**Display**

Subject: **FLICKER, WHITE BALANCE CHANGE (2)**

Model: **PVM-8040**

**Figure 1**

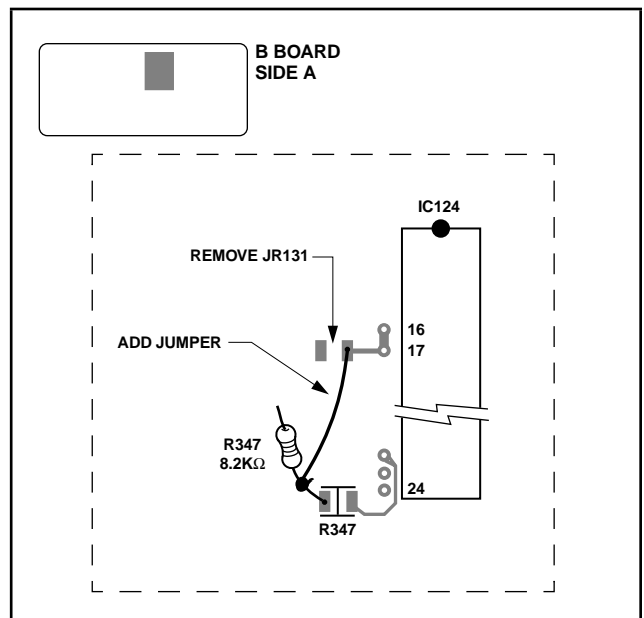
In units with S-MIC chassis, when a signal is fed into the current feed-back IC (CX1478S), it may erroneously detect a reference pulse and cause flicker and white balance variations during video reception.

**B Board, Side A (See Figure 1)**

1. Remove 0Ω chip resistor (JR131) (zone C-9, side B).
2. Solder a jumper wire between R347 (zone D-9) and trace leading from IC124-16.

**Figure 2**

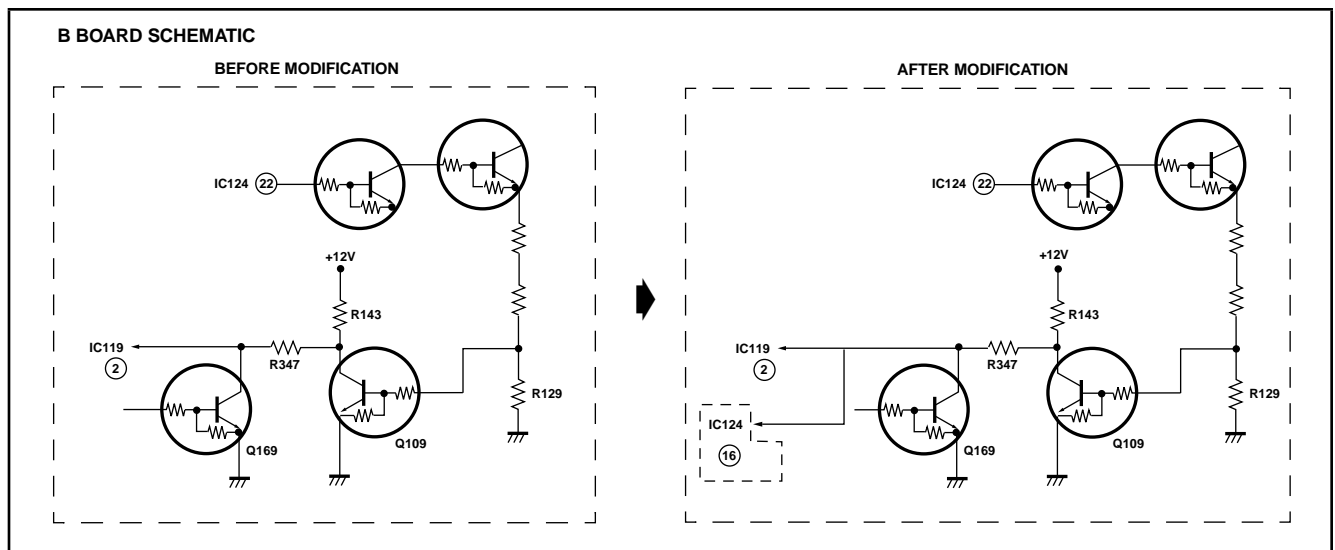
The circuit modification is shown on the B board schematic in Figure 2.
